EXHIBIT D

Subject: Landslide Hazard Evaluation, Chappellet Vineyard
APN's 032-010-076 and 032-010-094

Subject: Response to comments on Chappellet Vineyards Landslide Hazard Evaluation associated with #P20-00271-ECPA Sage Canyon Road: APNs 032-560-022 and -033

Figure 1. Project site with proposed vineyard areas, geology, soils and previously mapped landslides.

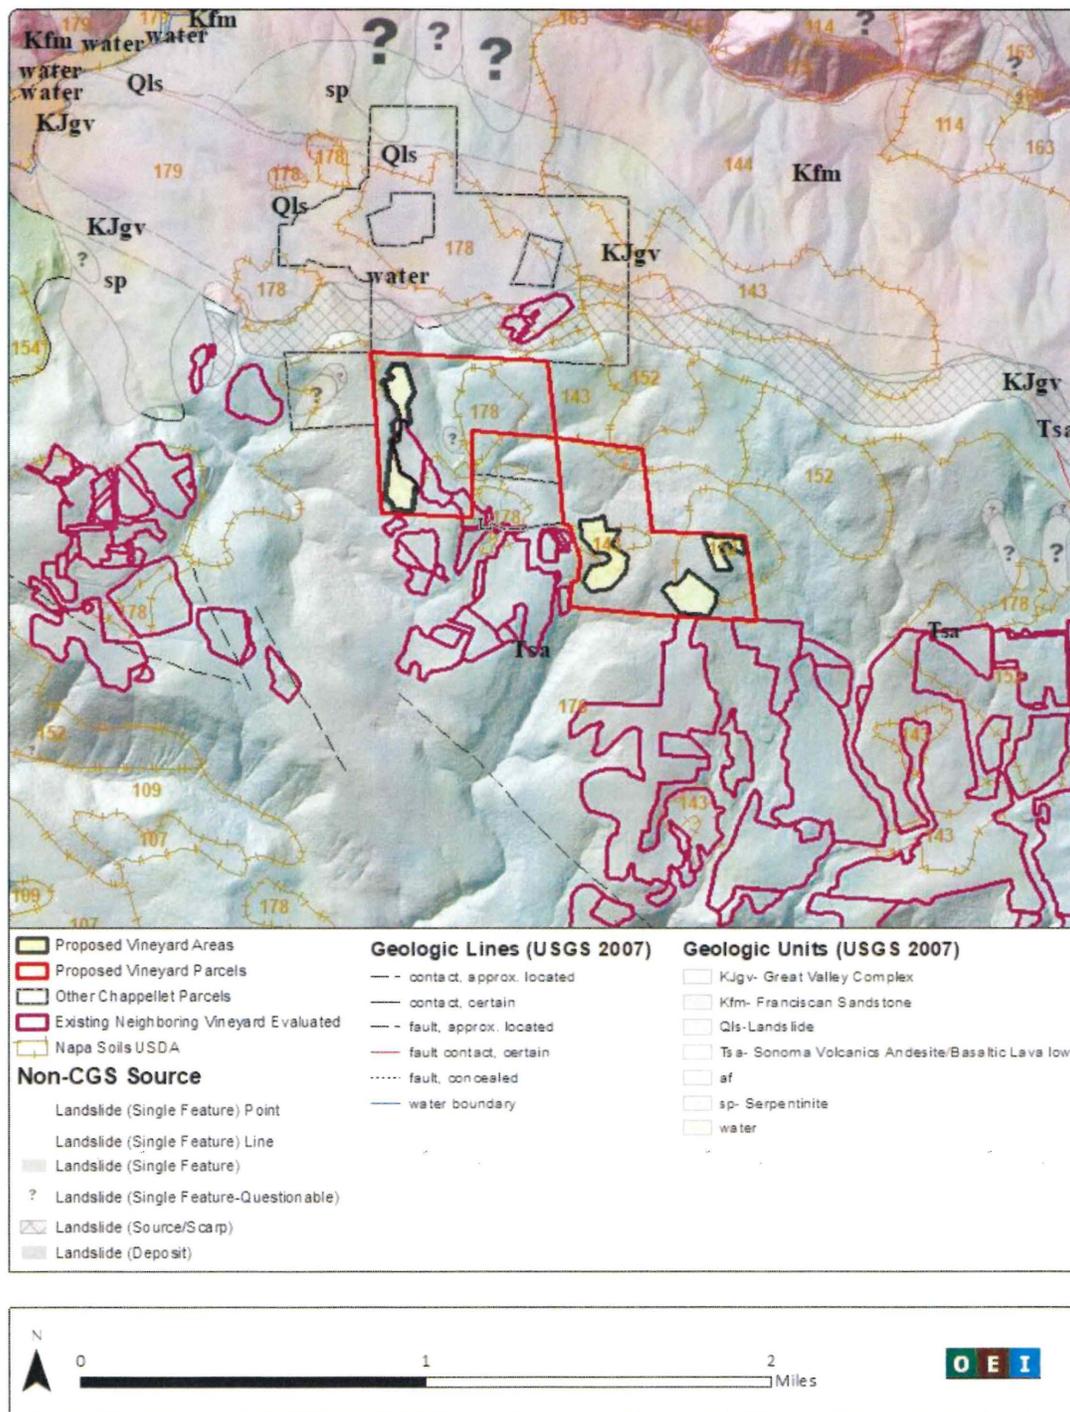
i. The effects on slope stability due to the proposed ECPA related to increased infiltration due to proposed ripping depths. The report should also provide ground preparation recommendations to maintain slope stability.

Owing to the hydrogeologic characteristics of the volcanic rock on Pritchard Hill, ripping and removal of rock is unlikely to significantly affect subsurface hydrology and infiltration. The process of vineyard field preparation is likely to increase the relative proportion of soil to large rock in vineyard fields, but is not expected to affect the extent to which fractures and other void spaces present in underlying volcanic rock permit infiltration of water from the overlying residual soil. The changed proportions of soil and rock in prepared fields is not expected to significantly alter the water holding capacity of the soil. Hence we do not believe that the proposed field preparation process will significantly affect water infiltration processes.

Furthermore, all slopes within proposed vineyard areas have gradients less than 30% with some small areas of >30% slope. As stated in OEI (2020): “In most non-cohesive earth materials, potential instability is generally very low on slopes less than out 50% and may typically be found to be significant on slopes greater than 65%.” (p. 7) Because of this fundamental characteristic of non-cohesive soils, we do not believe that proposed site preparation including ripping to an average depth of 3 feet within the proposed vineyard areas will cause a decrease in slope stability.

Aerial and LiDAR Imagery. Finally, aerial imagery and recent LiDAR topographic data were reviewed for the Pritchard Hill area, particularly those areas with developed vineyards with in soils and geology similar to the project area. Figure 1 shows existing vineyard areas where this additional review was made in and around vineyards where rock removal and soil ripping has occurred. Available aerial imagery on Google Earth covering the period between 2002 and the present did not reveal any evidence of landslides in these

areas. Further review of hillshade terrain maps and slope gradient maps derived from recent 2018 LiDAR data collected by USGS¹ did not reveal any landslides or unstable slopes in areas located on nearby upland plateaus and rounded ridgetops within the Tsa bedrock unit (Figure 1). Slopes across all vineyard areas are generally less than 30% per county requirements and therefore it is not surprising that no evidence of landslides or unstable slopes were remotely identified. Anomalous steeper slopes near vineyard areas were always associated with piles of rock removed from the adjacent fields.

The absence of landslides or unstable slope features associated with vineyard fields developed where rock removal and soil ripping in areas of similar slopes soils and geology is compelling evidence that these practices are not expected to reduce slope stability or cause erosion associated with landslides or other mass wasting processes.
